**PORT OF BEAUMONT
BEAUMONT, TEXAS**

ADDENDUM NO. 1

PORT OF BEAUMONT MAINTENANCE DREDGE PROJECT

APRIL 27, 2020

Discharge Point

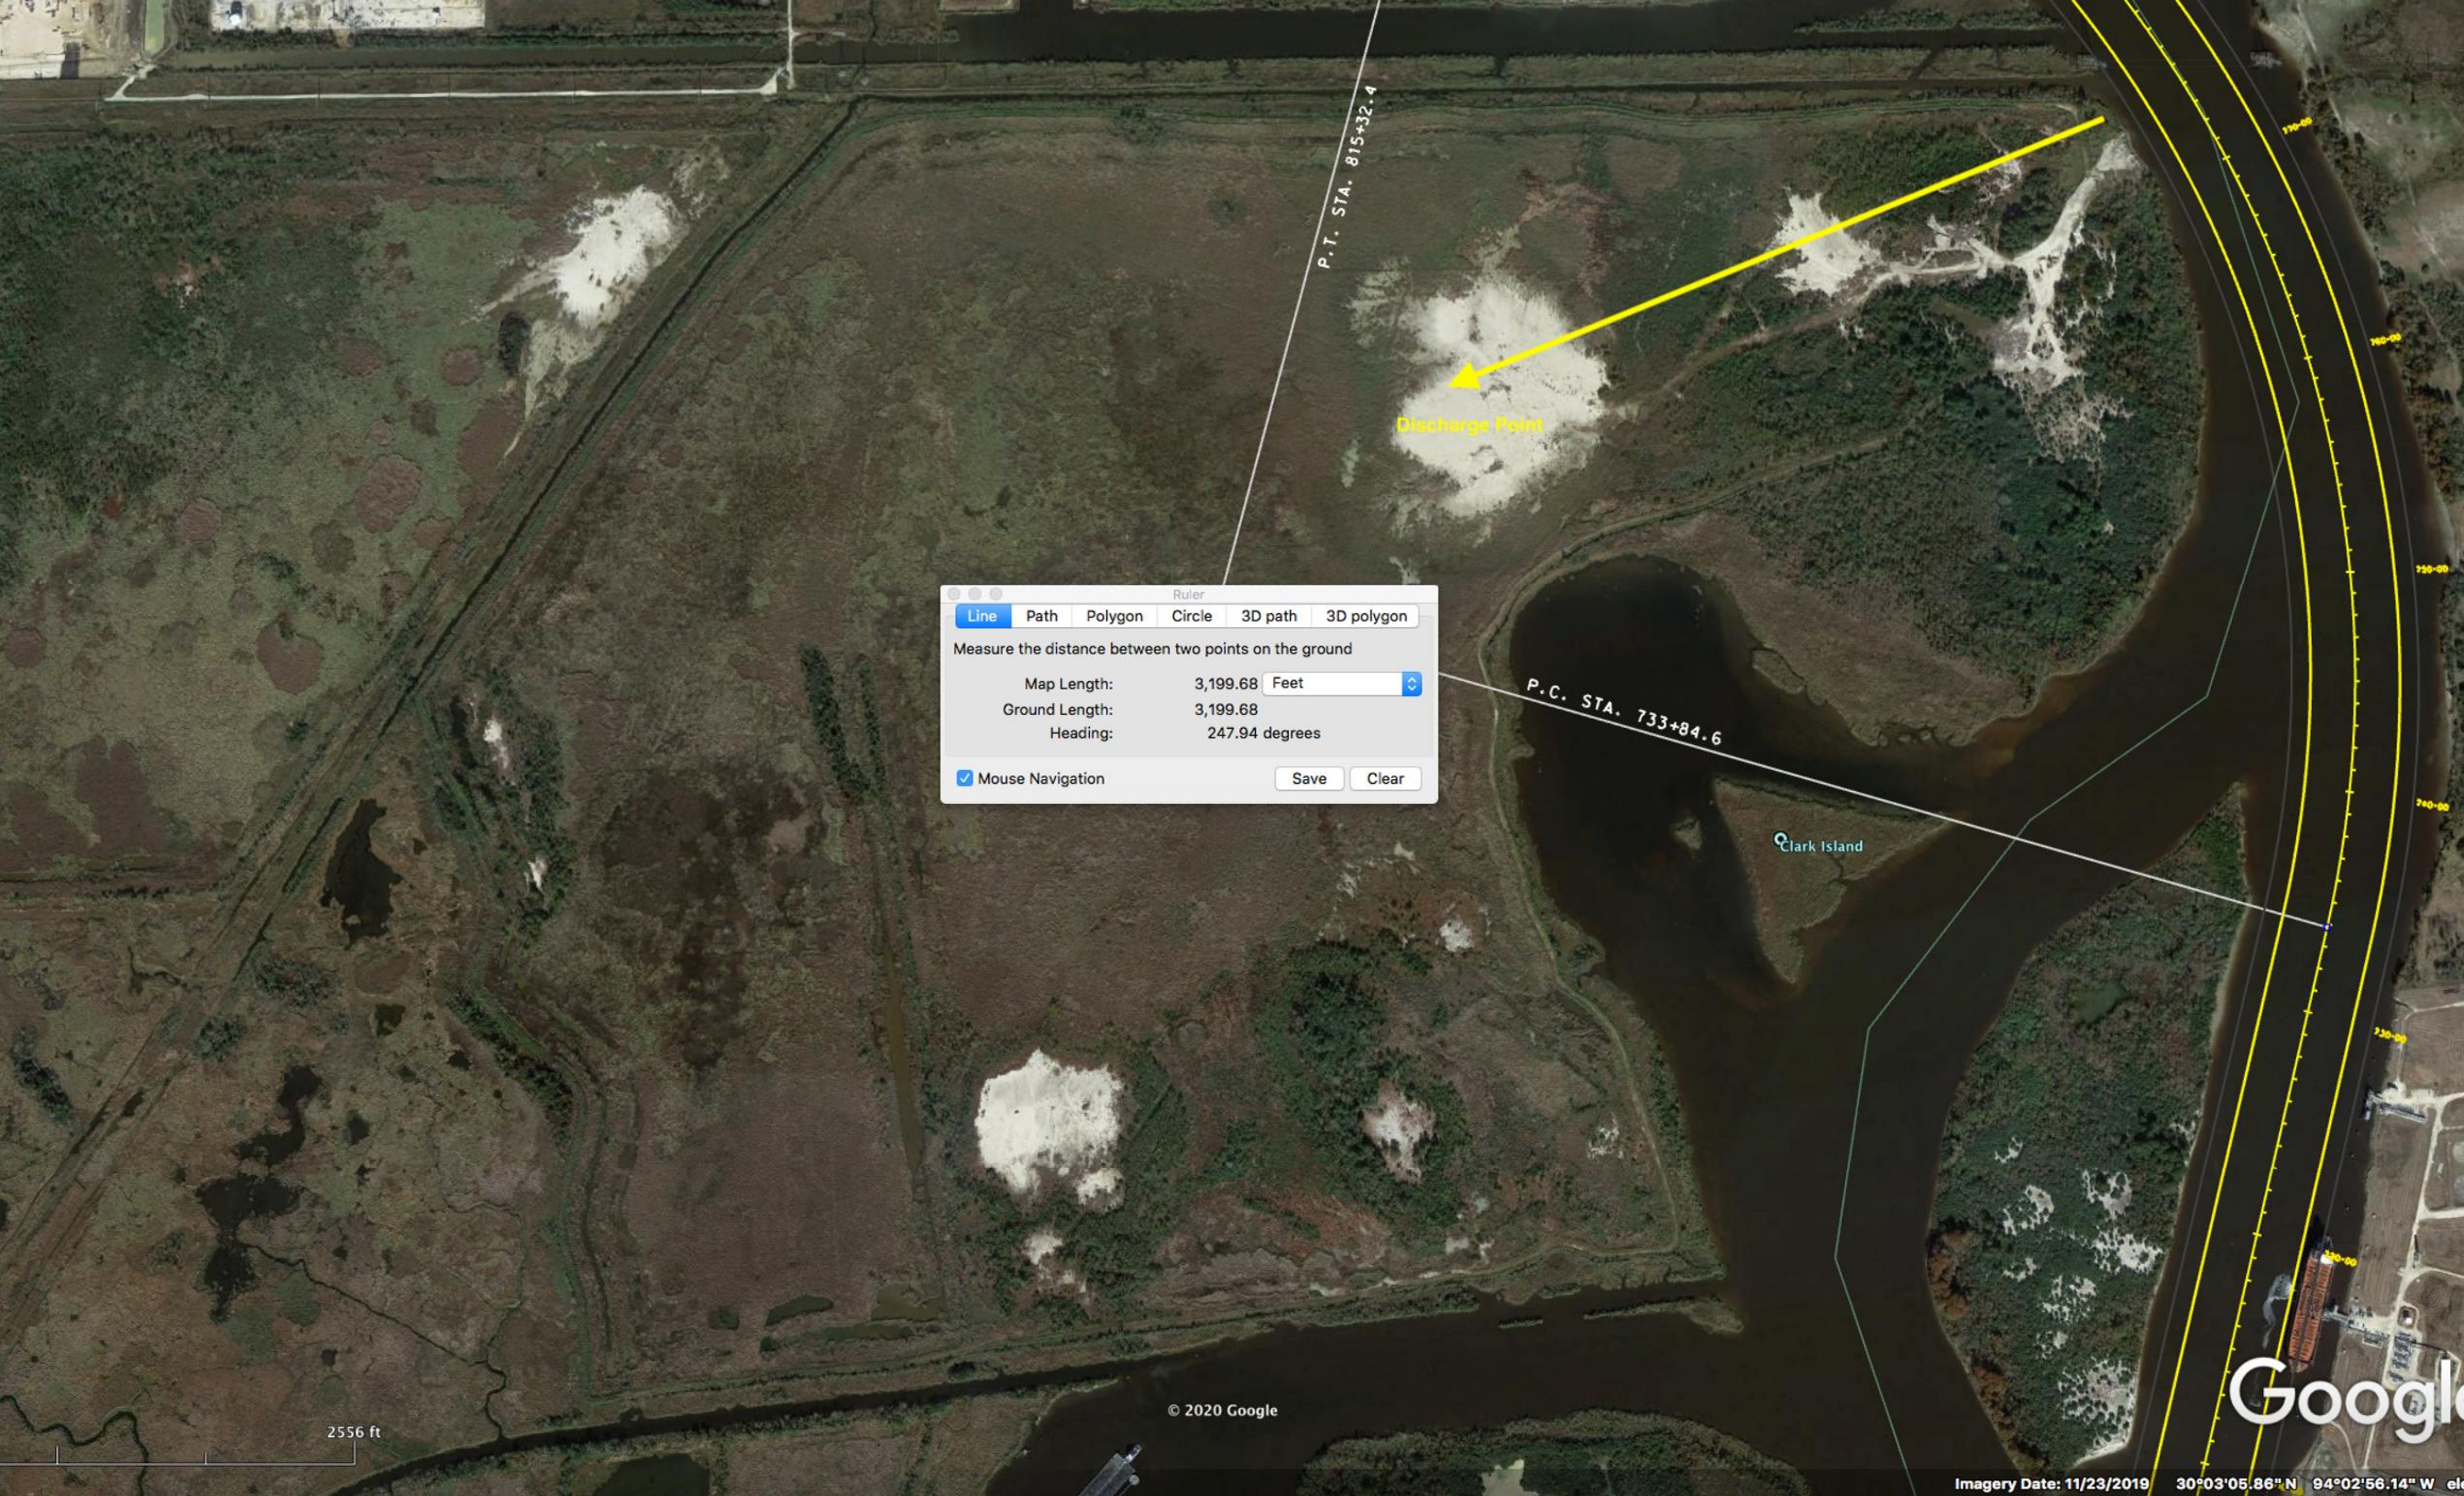
Question #4: Sabine Neches Navigation District (SNND) Discharge Point Location

Answer: The SNND has provided a Google Image showing the requested discharge point location for Placement Area 25. This image has been included in Appendix A. Please note that the selected contractor will still be responsible for contacting Larry Fountain with the SNND at (409) 729-4588 prior to dredge operations to confirm this location and to inform the SNND of the planned start date of the project.
